SUPPLEMENT 4

Gadsden K8 School

Allstate Construction, Inc.

November 7, 2025

Z-07d Fencing
Allstate Construction, Inc.
10-17-2025 Revised 11-07-2025

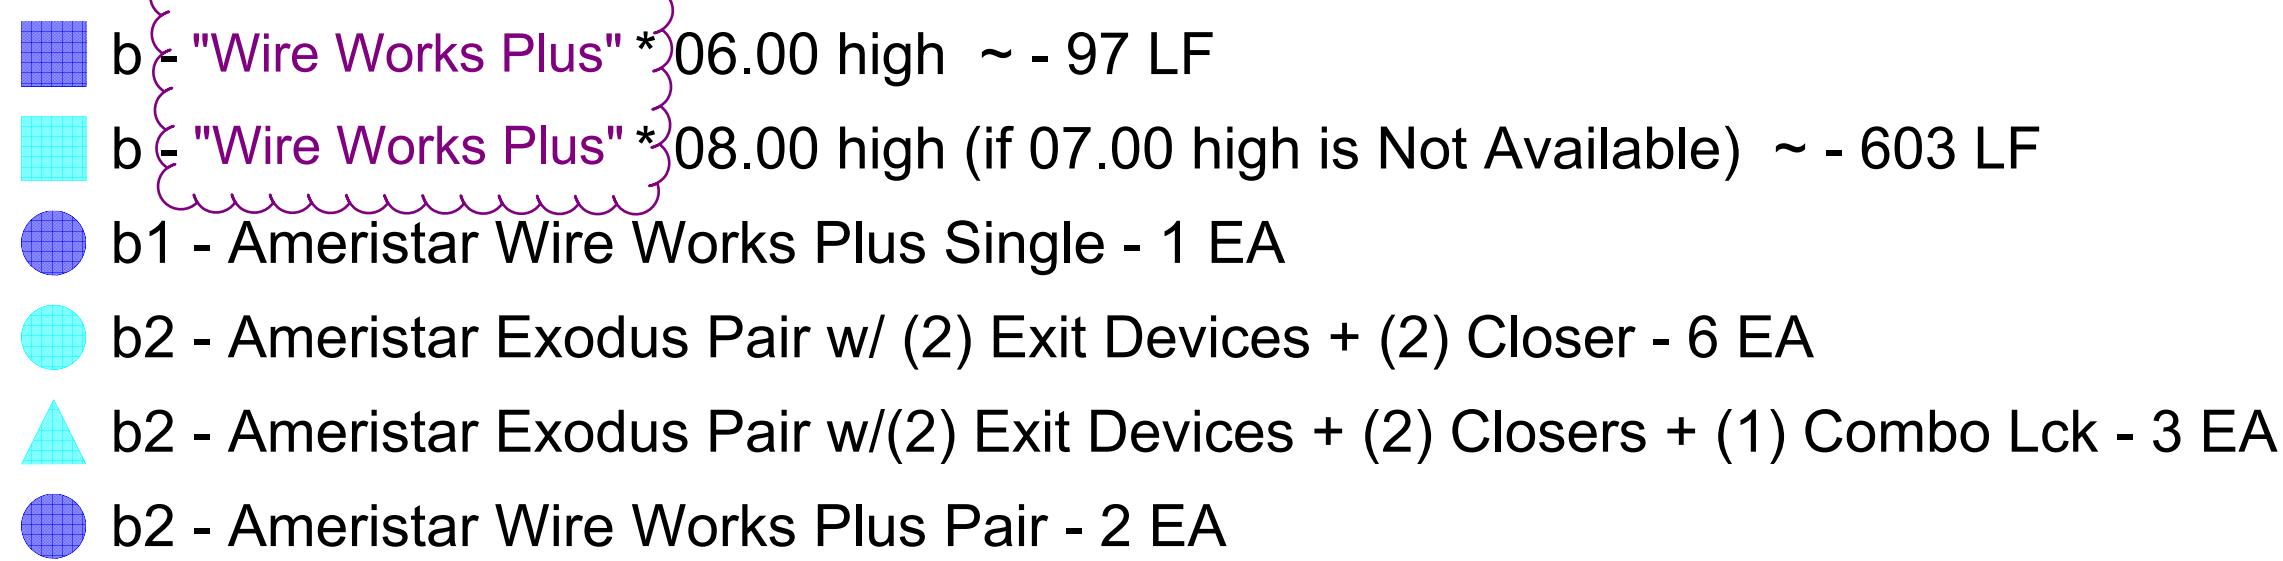
- Z-07d Fencing
- Z-07e Fencing
